***Traffic and
Transportation
Assessment***

Residential Development at Kingston,
Knocknacarra, Galway.

Traffic and Transportation Assessment

3.2.5 Cyclists Junction Visibility – Kingston Road

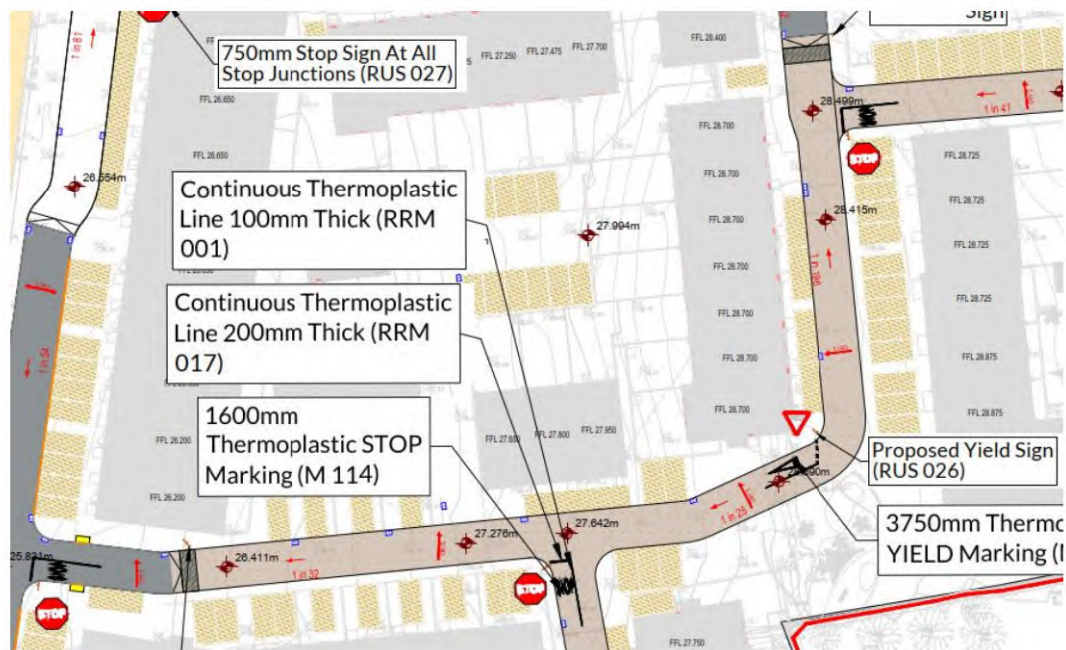
Problem: Cyclists from the development have visibility onto Kingston Road restricted in both directions by boundary walls and vegetation.

Hazard: Cyclists may exit the development junction into the path of oncoming vehicles, cyclists or pedestrians.

Recommendation: The Design Team should ensure cyclists visibility is achieved to both the carriageway and footpath.

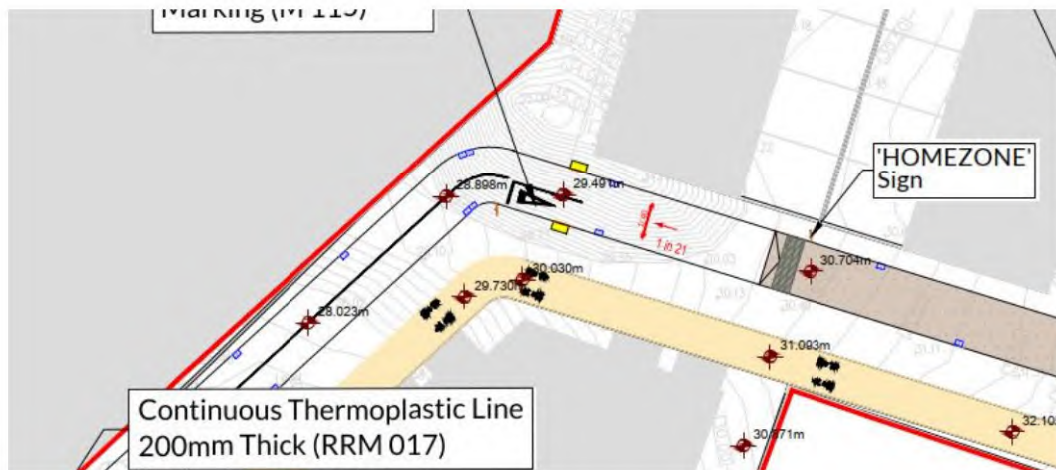
Hazard: Motorists may impact with pedestrians, possibly children playing in the home zone.

Recommendation: The Design Team should amend the design to reduce the vehicle dominance of these areas.

Reference to the DMURS publication should be made in this regard.

- **Response:** The design team accepts the problem and recommendation with the proposed home zones designed in accordance with the design principles of DMURS. A road width of 4.8m has been implemented throughout the homezone areas, which reduces vehicle speeds and vehicle dominance. Where perpendicular parking spaces are provided, an additional 1.2m of delineated homezone area is provided to enable vehicle access to parking spaces. The paving delineation will be provided as per DMURS section 4.4.2, please refer to drawing numbers 11893-2009, 11893-2010, 11893-2011 & 11893-2012 for details.

3.2.10 Termination of Active Travel Path

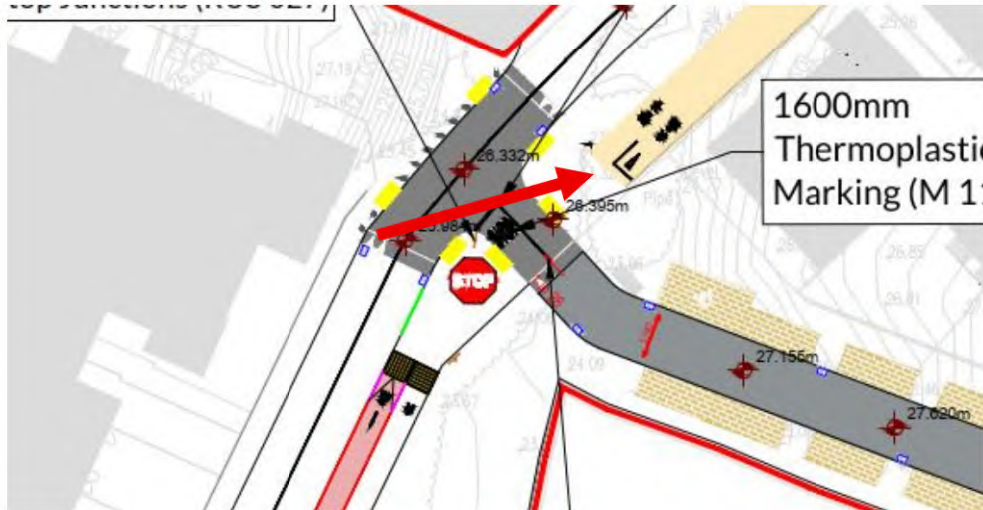
Problem: It is not clear from the design what the cyclists is meant to do at the start and end of the active travel path.

Hazard: Cyclists may cut in front of motorists vehicles when leaving / rejoining the carriageway. Impact between users may result.

- **Response:** The design team accepts the problem and recommendation with the start and ends of the active travel paths updated to accommodate safe transitions to/from the carriageway for cyclists, please refer to drawings 11893-2009 & 11893-2011 for details.
